REPORT TO THE SUBDIVISION AND DEVELOPMENT APPEAL BOARD

DATE: November 26, 2026	**APPEAL NO.: SDAB2026-0117** **FILE NO.: DP2026-01095**
APPEAL BY: Curt Rohm	
FROM A DECISION OF THE DEVELOPMENT AUTHORITY where a **New: Townhouse (1 building), Secondary Suite (4 suites), Accessory Residential Building (garage)** **was approved at <u>525 22 Avenue NE.</u>**	**LAND USE DESIGNATION: R-CG** **Discretionary**
COMMUNITY OF: Winston Heights/Mountview	**DATE OF DECISION: June 25, 2026**
APPLICANT: JOHN TRINH & ASSOCIATES	**OWNER/S: DAN DUY NGUYEN & HOA CONG TRAN**

The Board opened the hearing on August 18, 2026 with consideration of procedural and jurisdictional issues. The Board adjourned the hearing to November 26, 2026. This is the interim report which contains a by-law check of discrepancies submitted by the Development Authority as per the Board's direction.

DRAWING SET:
DP
SHEET NAME:
Basement Plan
PAGE: **A-1.1**

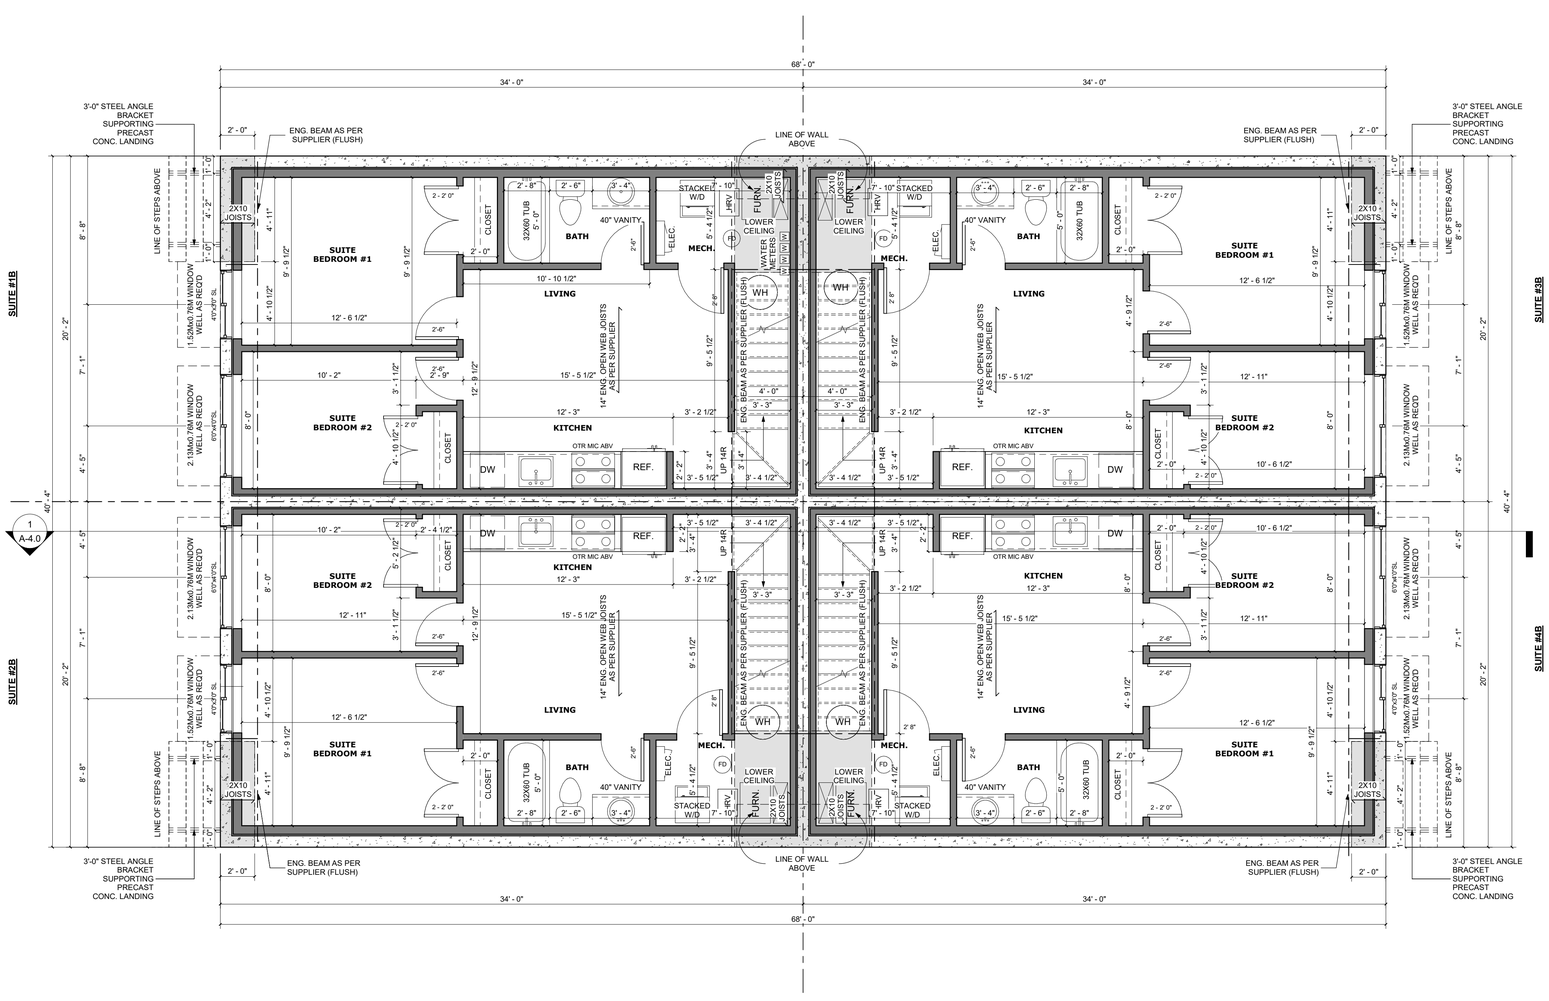
14. Amend plans (A-1.1) to correctly label dwellings as suites. They are currently labelled as units.

14. Amend plans (A-1.1) to correctly label dwellings as suites. They are currently labelled as units.
Amended. Refer to A-1.1.

DRAWING SET:
DP
SHEET NAME:
Left & Right Elevation
PAGE: A-2.1

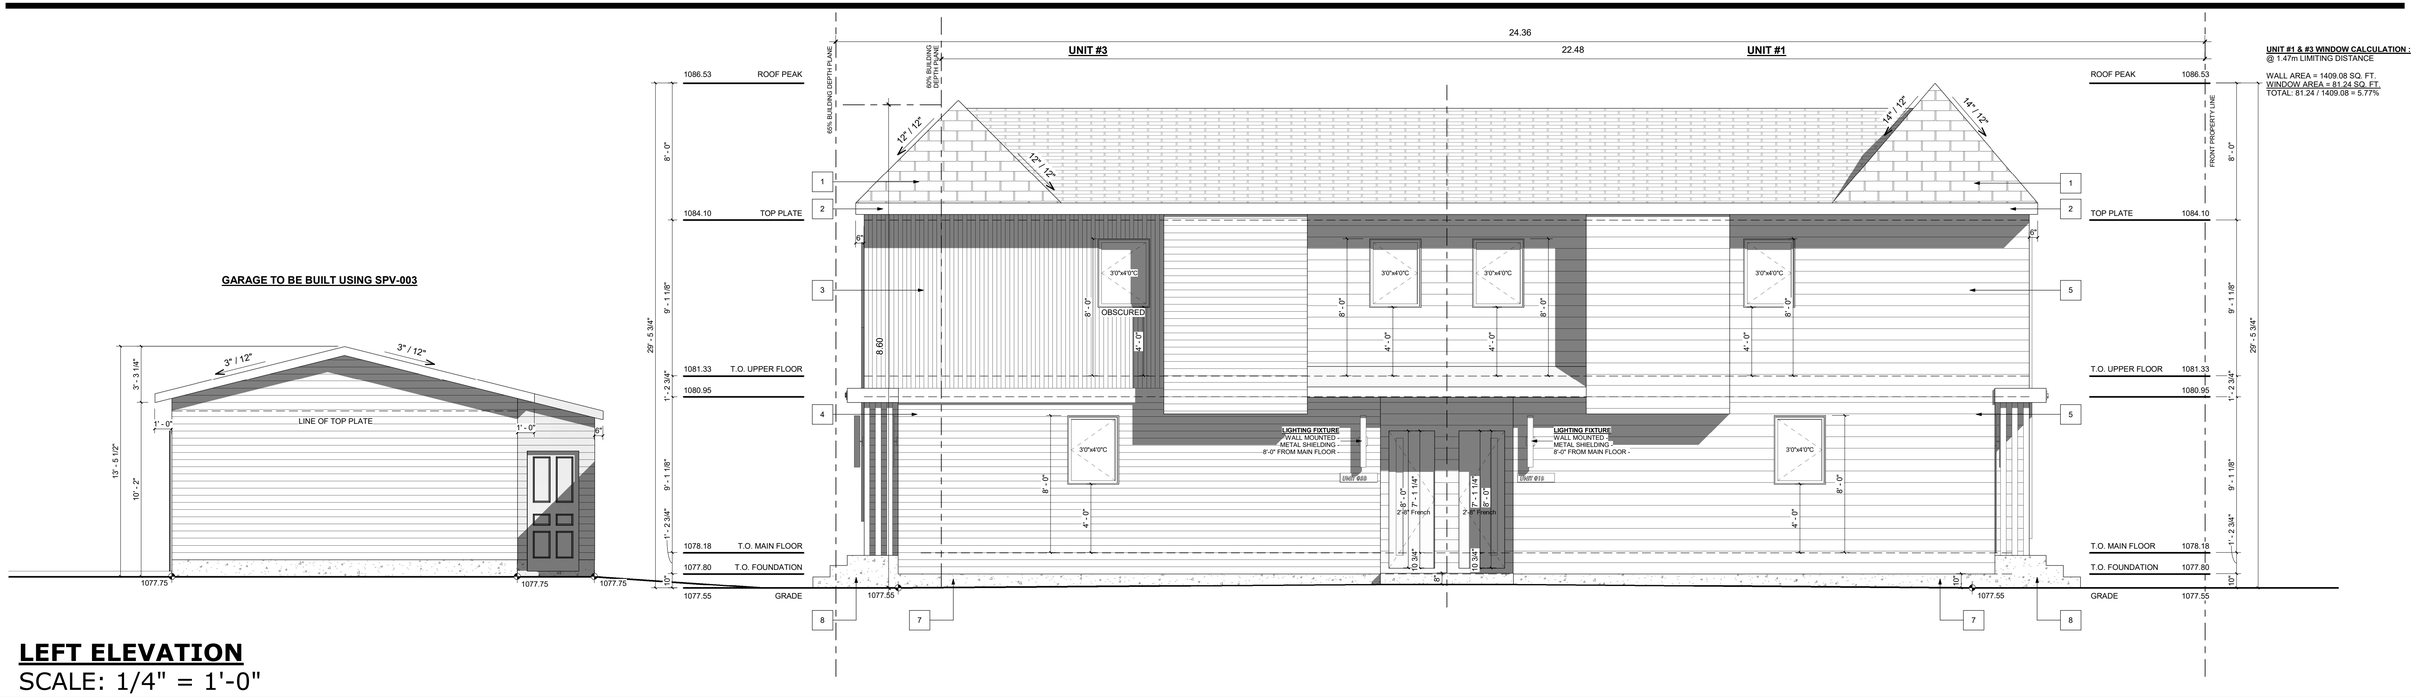
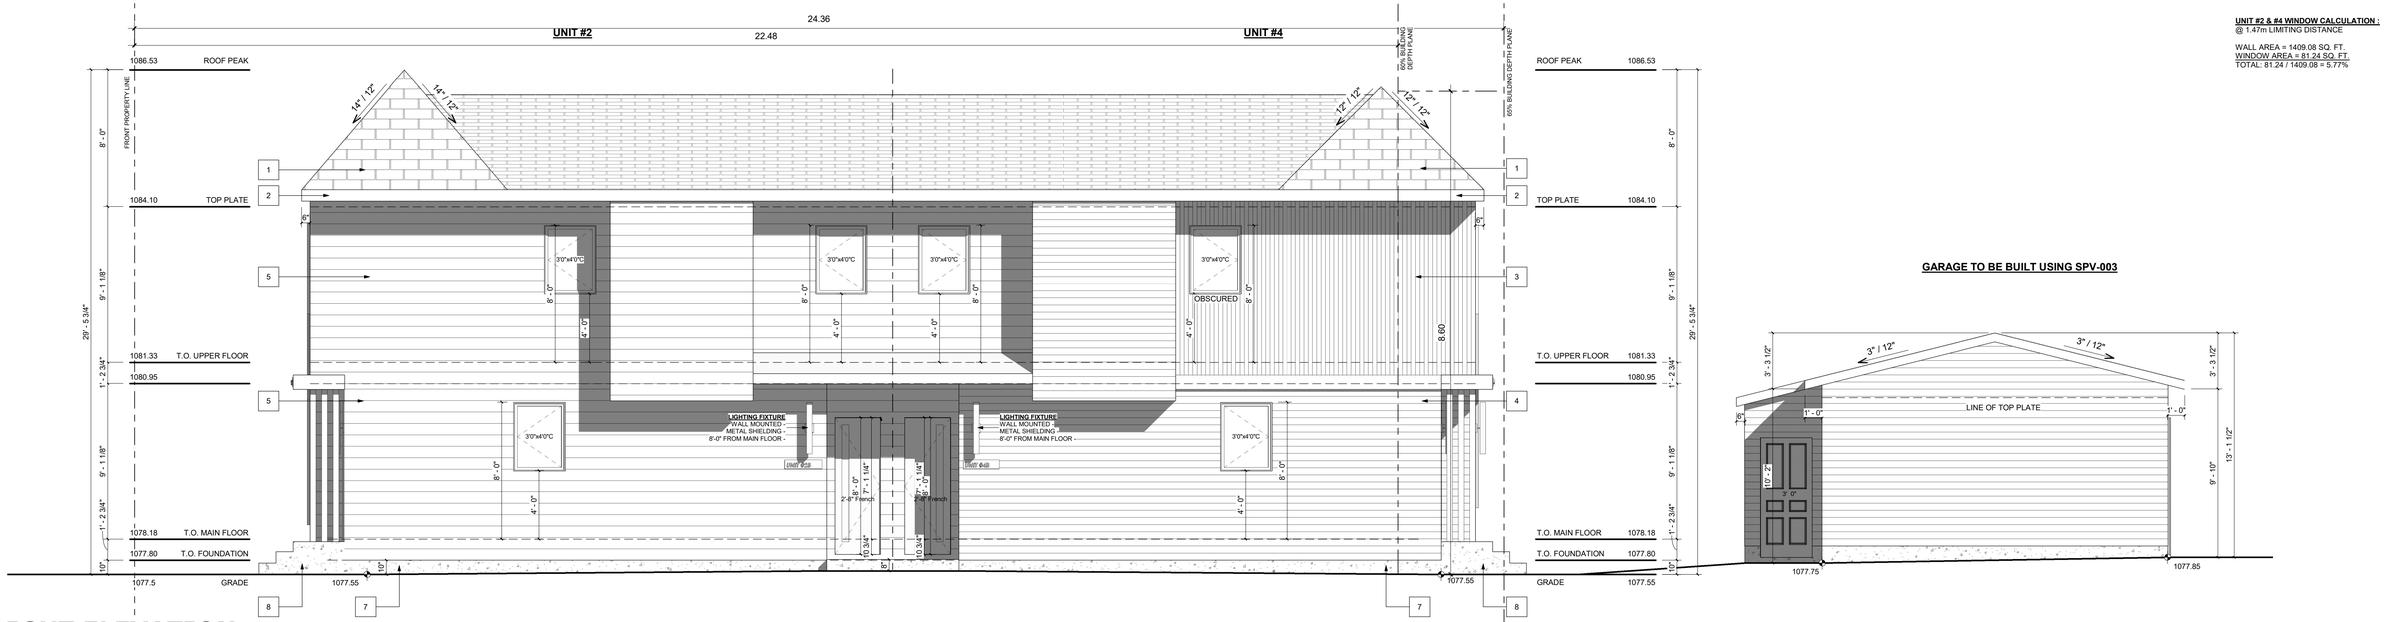
The North Hill Communities LAP (Section 2.7.1) emphasizes pedestrian routes should be well-lit. The submission does not currently identify locations for site lighting or demonstrate how CPTED (Crime Prevention Through Environmental Design) principles have been incorporated into the design. Adequate lighting is essential for visibility, safety, and passive surveillance, and should be clearly shown on the site plan.
Amended. Lighting information is provided in A-2.1.

DRAWING SET:
DP
SHEET NAME:
Garage Plans & Elevations
PAGE: **A-3.0**

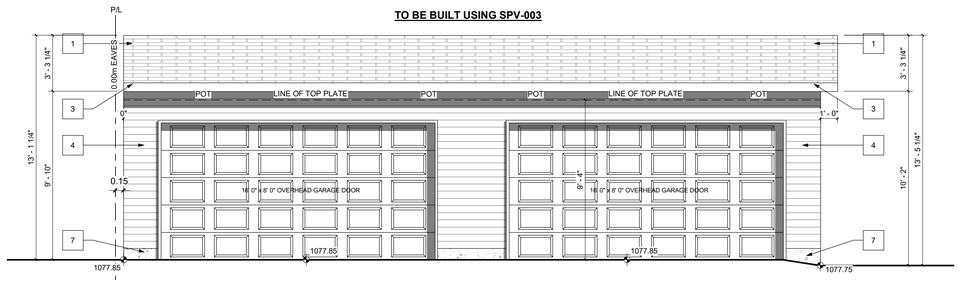
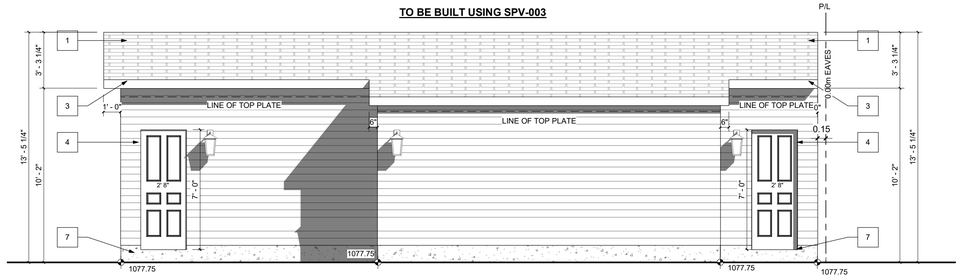
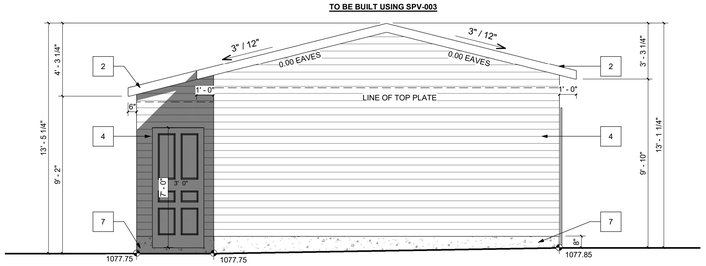
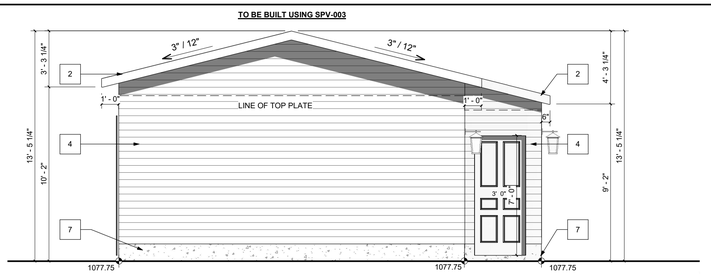
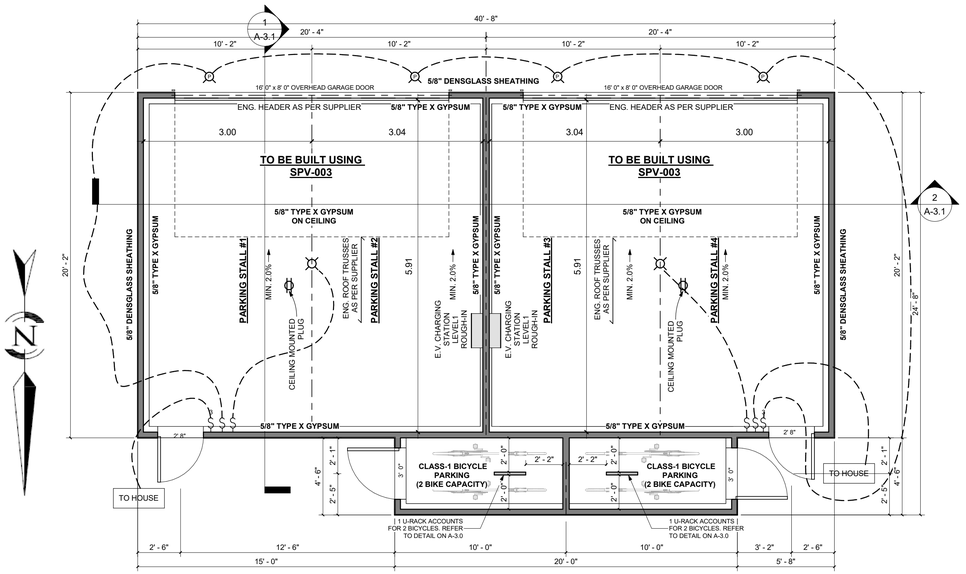
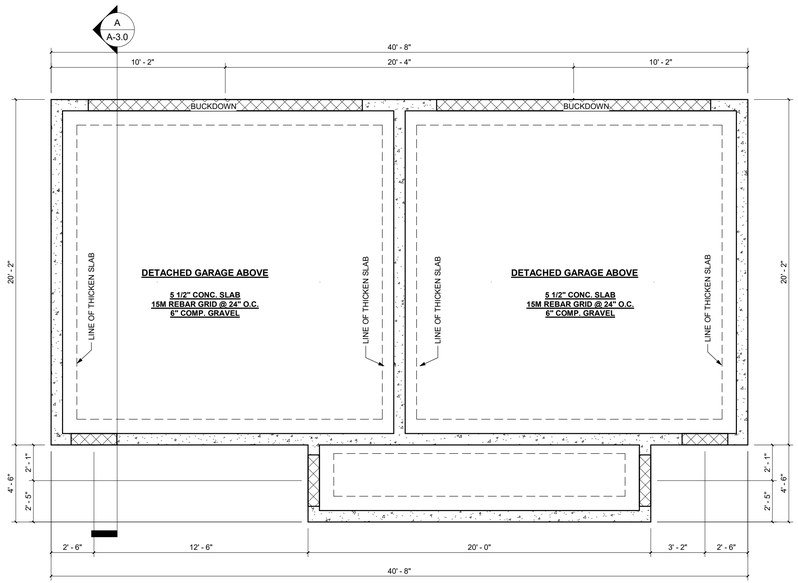
3. Amend the plans to distinguish the proposed EV charging between level 1 and level 2 EV chargers. Level 2 is recommended.
   E.V. charging station rough-ins are provided. Refer to A-3.0.
